TRIASSIC PARK WASTE DISPOSAL FACILITY
Gandy Marley, Inc.
Tatum, New Mexico

REQUEST FOR SUPPLEMENTAL INFORMATION
TRIASSIC PARK PERMIT APPLICATION

July 1999

REQUEST FOR SUPPLEMENTAL INFORMATION (RSI)
TRIASSIC PARK PERMIT APPLICATION
July 1999

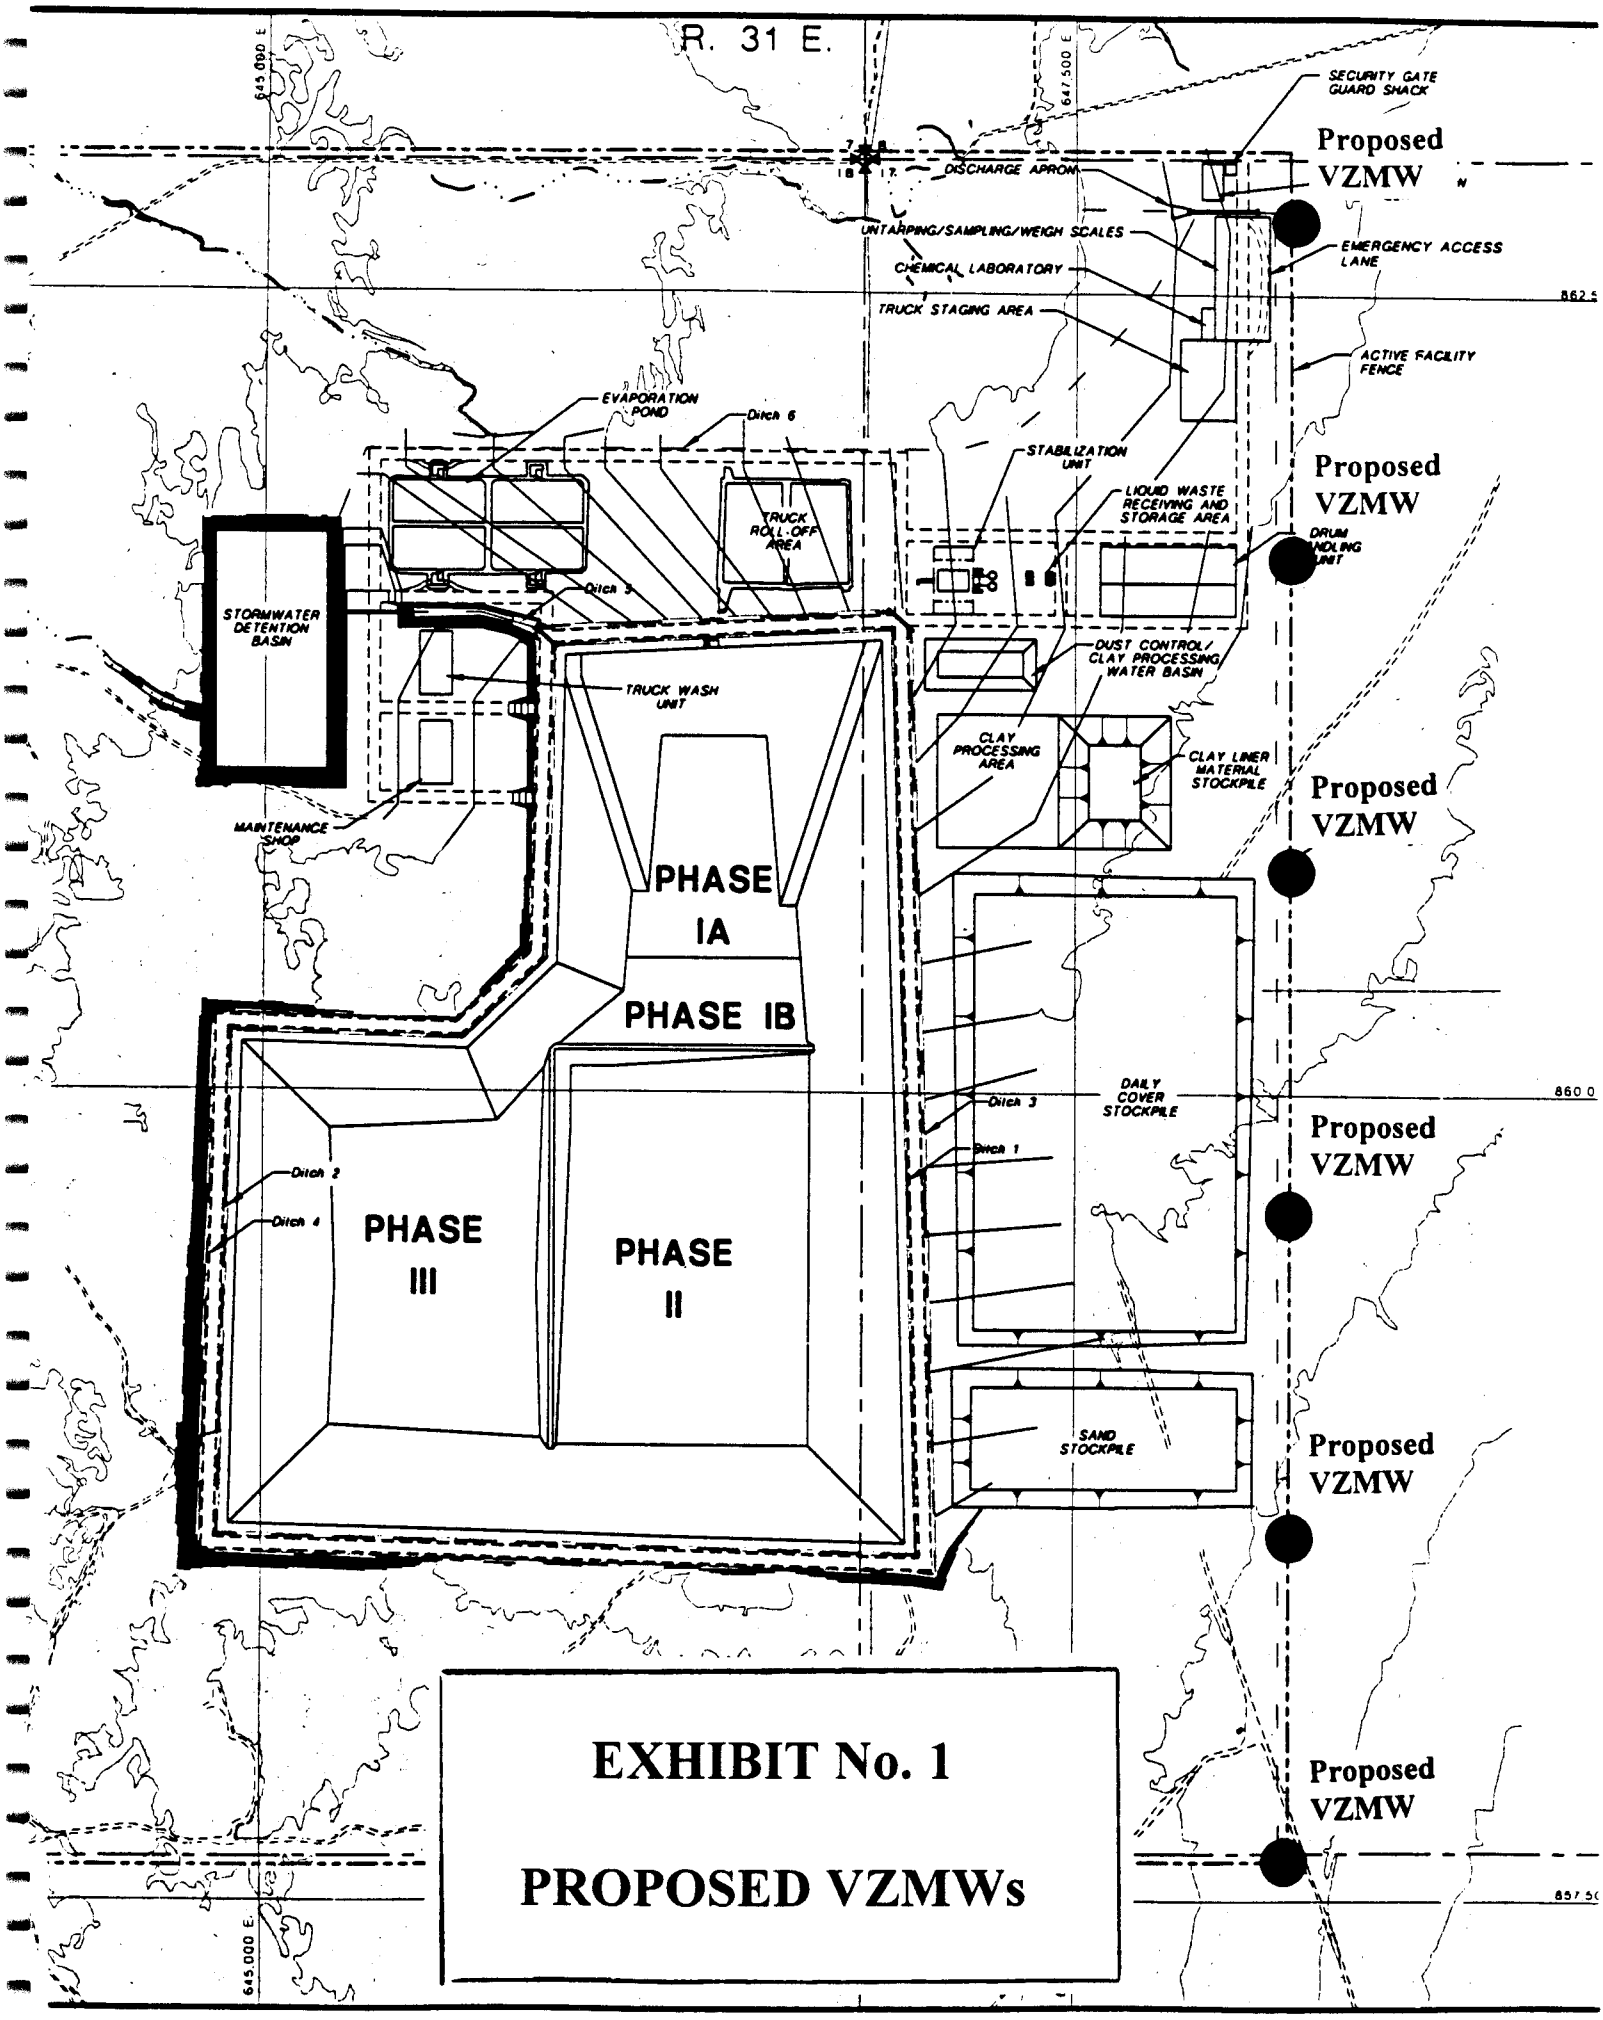
1. The geohydrologic investigation must be expanded to include the northern portion of the proposed site. Figure 3-14 (permit application, Vol. I) shows the southern portion of the proposed site having sufficient geohydrologic delineation, while all figures showing the proposed facility layout locate both the surface impoundment and the Phase 1 landfill in the northern portion of the site. A primary objective of the expanded investigation should be the determination of the presence of shallow groundwater below the northern portion.

Response: *Based on recent meetings, Gandy Marley is planning to conduct additional field investigations to further characterize the hydrogeologic conditions at the site. Based on the results of these investigations, an appropriate groundwater monitoring system for the site will be proposed in the revised Permit application.*

EXHIBIT No. 2

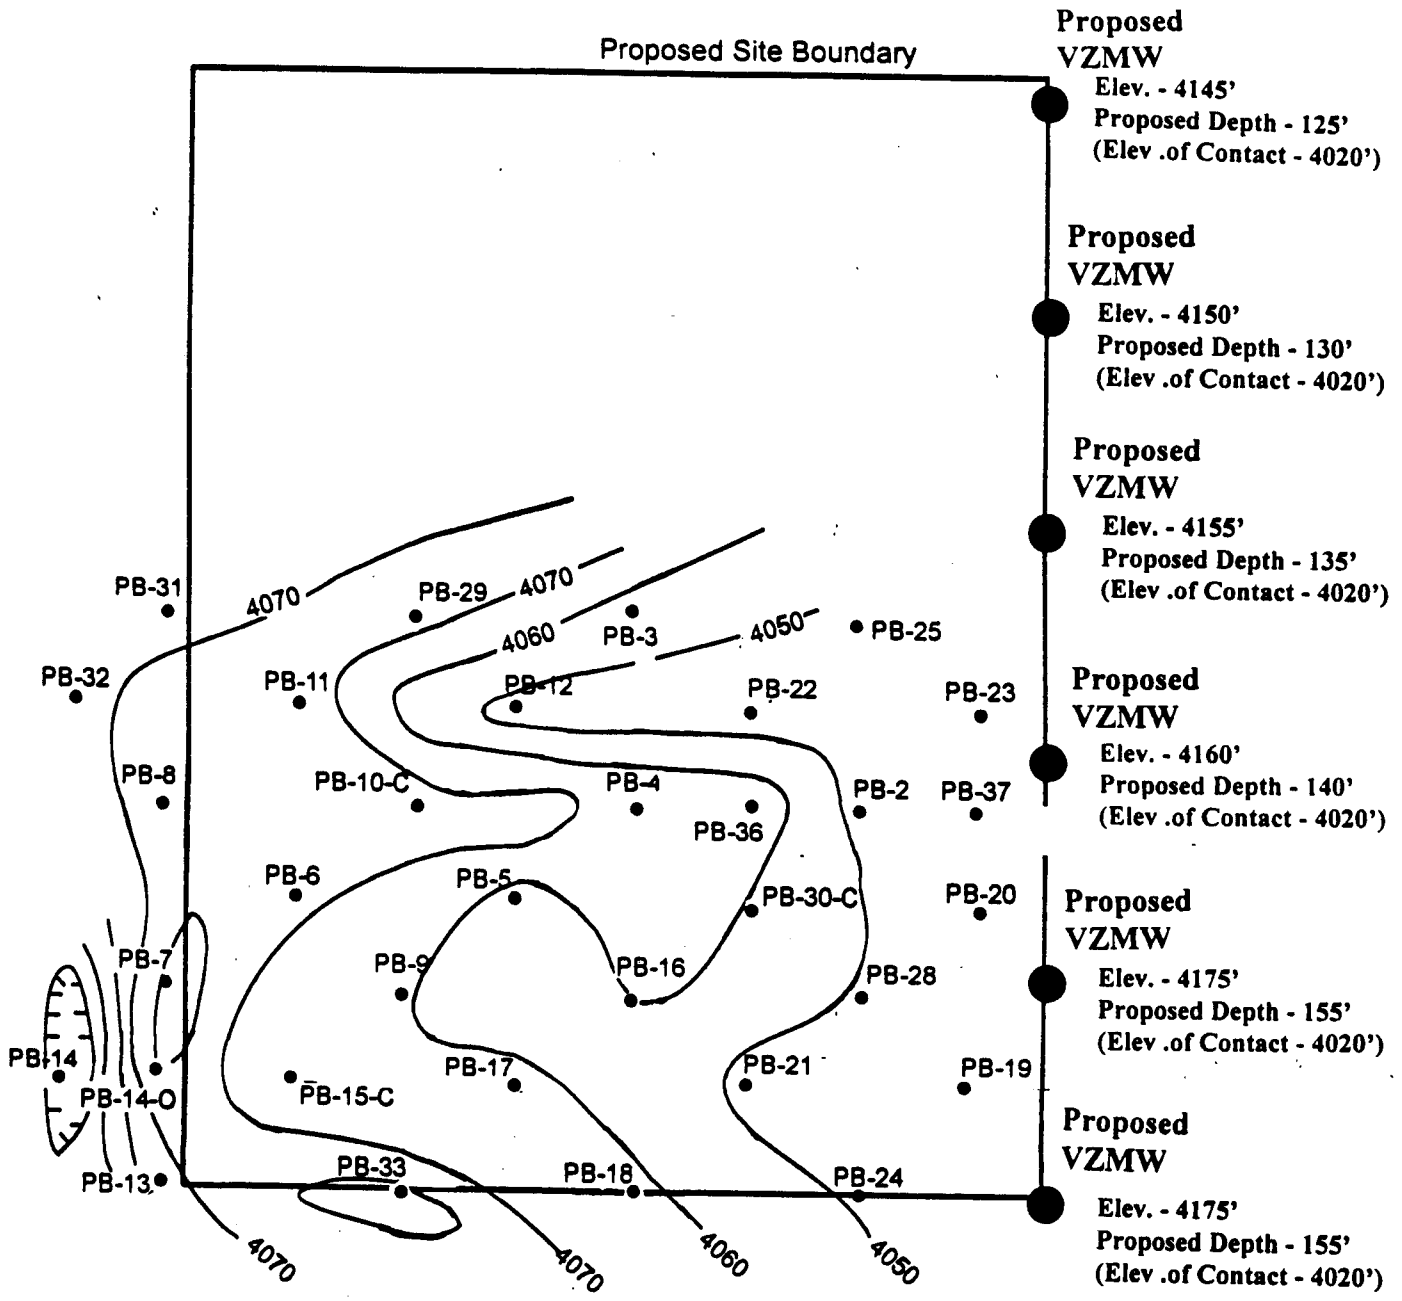
- These logs appear to be the primary evidence used to both delineate ground water and to pick the boundary between the Upper and Lower Dockum Formations. Please explain in substantial detail the significance of these two geophysical logging techniques, particularly the chemical and physical properties they measure, how they distinguish between the Upper and Lower Dockum lithologies and how they determine the presence of ground water. Please provide information regarding the influence of well casing and a fluid-filled hole on these logs.

The importance of recognizing the Upper and Lower Dockum boundary is to ensure that the base of the proposed landfill will be placed on the top of the Lower Dockum. The thick sequences of mudstones within this unit provide an excellent geologic barrier (another level of protection) to any potential downward migration. In those areas where there is an inferred contact, the lithologies are mudstones. Despite the inferred contact, the important consideration of establishing a permeability barrier has been accomplished.
